**SUSQUEHANNA STEAM ELECTRIC STATION,
AMENDMENT REQUEST NO. 303 TO LICENSE NPF-14 AND
AMENDMENT REQUEST NO. 273 TO LICENSE NPF-22:
TECHNICAL SPECIFICATION CHANGE TO TECHNICAL
SPECIFICATION 3.6.1.3 TO INCREASE THE MAXIMUM
ALLOWABLE SECONDARY CONTAINMENT BYPASS
LEAKAGE LIMIT
PLA-6392**

**Docket Nos. 50-387
and 50-388**

PPL Susquehanna, LLC Evaluation of Proposed Change to the Unit 1 and Unit 2 TS 3.6.1.3 "Primary Containment Isolation Valves (PCIVs)"

Figure 1

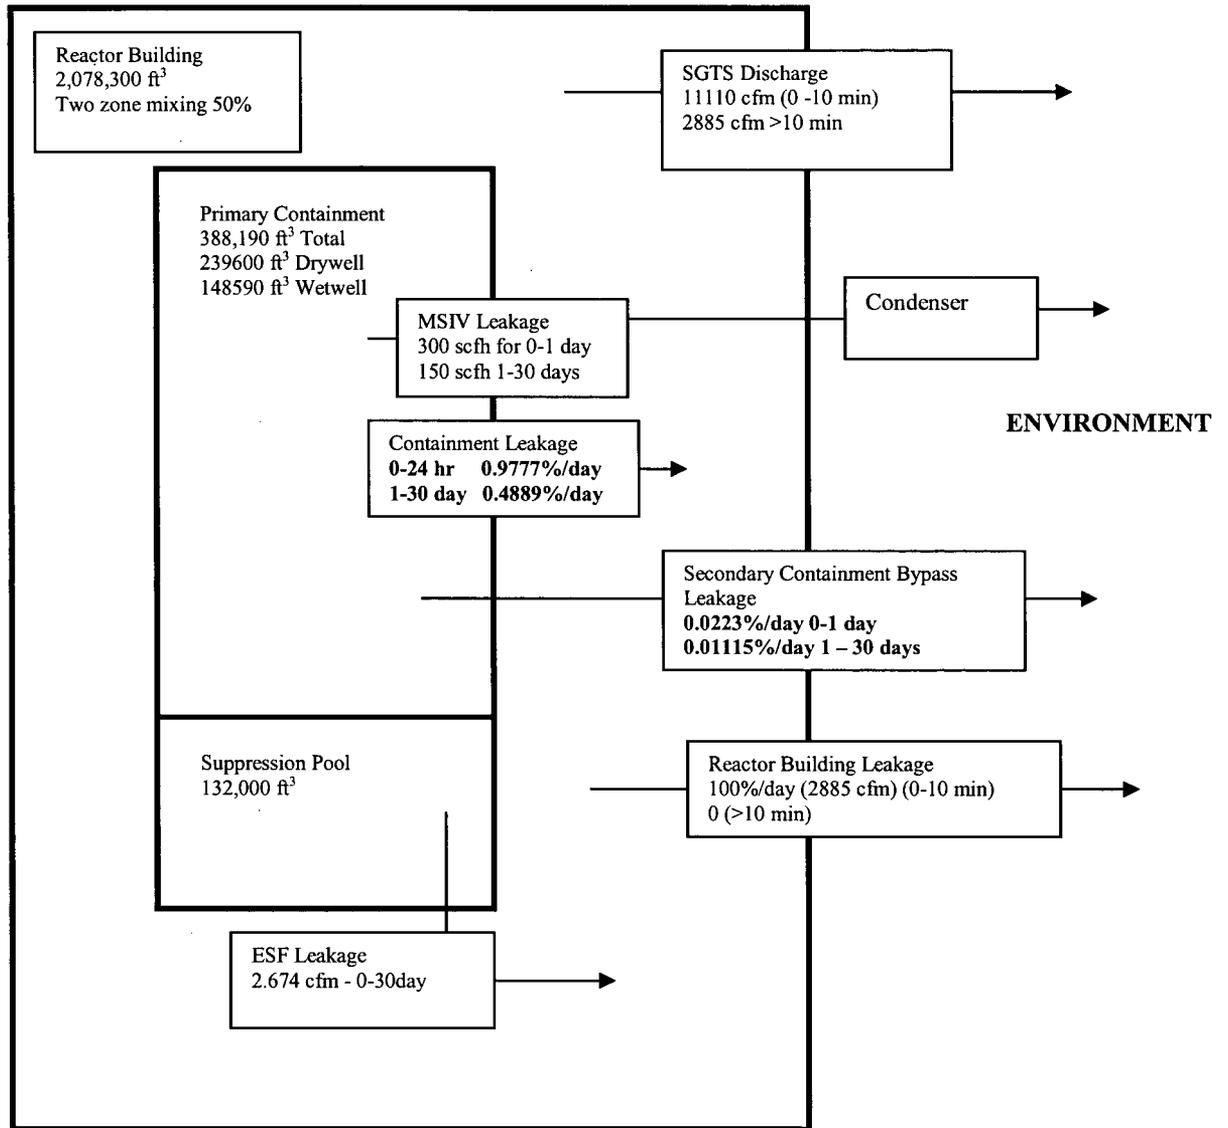
Note 1: For the LOCA, the primary containment and ESF leakages to the secondary containment are released to the environment via the SGTS vent. The primary containment bypass and MSIV leakages are released to the environment via the Turbine Building exhaust vent. Figure 1 depicts the analysis release paths and release rates used in the analysis.

Note: Only the bolded values are changed by this proposed change.

1. Secondary Containment Bypass Leakage was changed from 9 scfh to 15 scfh.
2. Primary Containment to Secondary Containment leakage has been changed from 0.9866%/day to 0.9777%/day to maintain total primary containment leakage at 1%/day.
3. The Control Room atmospheric dispersion (χ/Q) values that appear in the NRC letter dated January 31, 2007 (ML070080301), based on the as-built intake location, are used.
